# APPLICATION FOR PERMISSION UNDER SECTION 16 OF THE TOWN PLANNING ORDINANCE (CAP.131)

#### SEWER DRAINAGE PROPOSAL

# PROPOSED NETH DEVELOPMENT AT TAI YEUNG CHE VILLAGE, TAI PO, N.T.

#### **Reply to DSD's Comments**

Scale Figure No. 311/DR-02 1:750 Date Revision 05.12.2022 Α

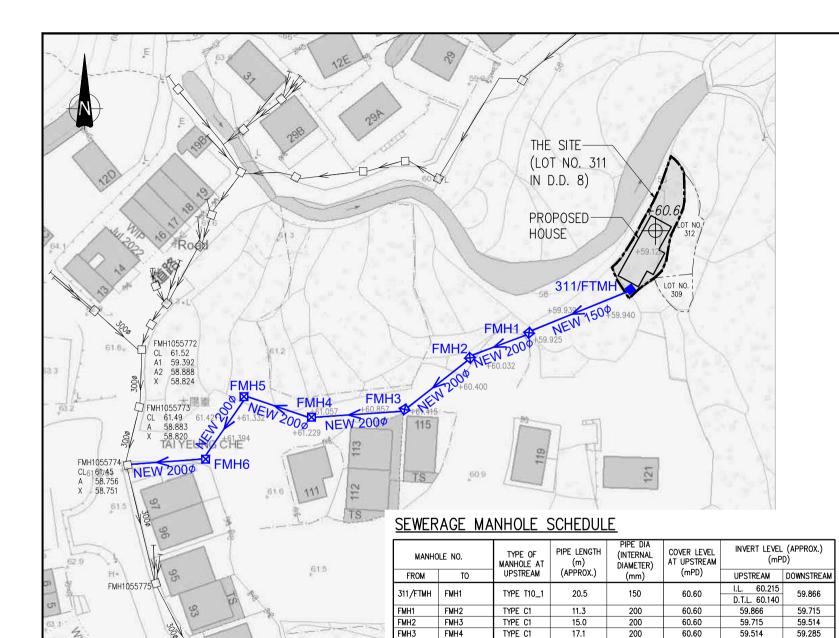
- (b) The proposed sewers from manhole 311/FTMN to manhole FMH3 will be laid and constructed above the existing ground. Such arrangement will block the existing overland flow to the nearest stream. The applicant shall demonstrate that the overland flow in the surrounding area will not be affected by the sewer laying works.
- Reply New surface channels and catchpits will be constructed alongside the proposed sewers from manhole 311/FTMN to manhole FMH3, as shown in Figure No. 311/DR-06. These surface U-channels can be used to intercept the surface runoff falling from the southern side of lands towards the existing stream.

- (c) The new sewer from manhole 311/FTMN to existing public sewer manhole FMH 1055774 will be located in private lots and government land. Prior consent and agreement from DLO/TP, DO/TP and/or relevant private lot owners should be sought before commencement of the proposed sewer laying works.
- Reply For works to be carried out in private lots and government land, permissions and consents from any relevant owners, including government departments/ maintenance parties/ private lot owners, will be obtained before carrying out the proposed drainage connection or laying of proposed drains and associated manholes.
- (d) The proposed sewerage from manholes 311/FTMH to FMH6 shall be maintained by the private owners.
- Reply Noted. All relevant private owners shall undertake the maintenance responsibilities for the proposed sewerage from manholes 311/FTMH to FMH6.

- (e) A minimum soil cover of 450mm and 900mm should be provided for the connection pipe constructed under footpath and carriageway respectively.
- Reply Note (4) in Figure No. 311/DR-02(A) is now added for such minimum soil cover requirement.

311/DR-03

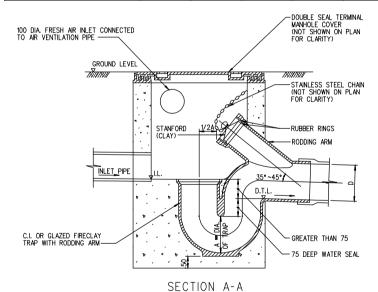
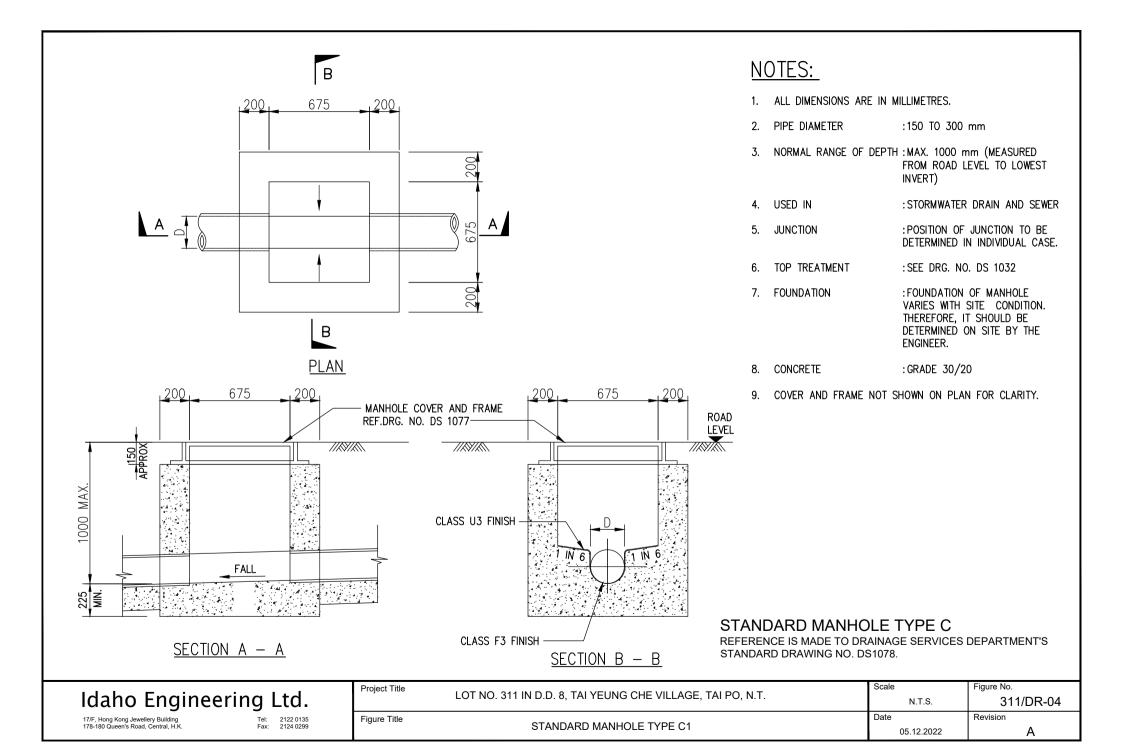
- (e) It is noted that the DS1094 is not applicable to the 200mm dia. outlet pipe. Please revise.
- Reply The outlet drainage pipe from manholes 311/FTMH to FMH1 is now revised to 150mm diameter. =
- (f) The gradient of the proposed pipes is smaller than the 1:75 stated in the LEGEND. Please review.
- Reply The proposed Invert Level (I.L.) of all drainage pipes are now revised such that they will have a minimum gradient of 1:75.
- 2. In addition, please remind the applicant's A.P. of the following general comments/requirements on the drainage works.
- (a) The proposed drainage works, whether within or outside the lot boundary, should be constructed and maintained by the lot owner at his expense.
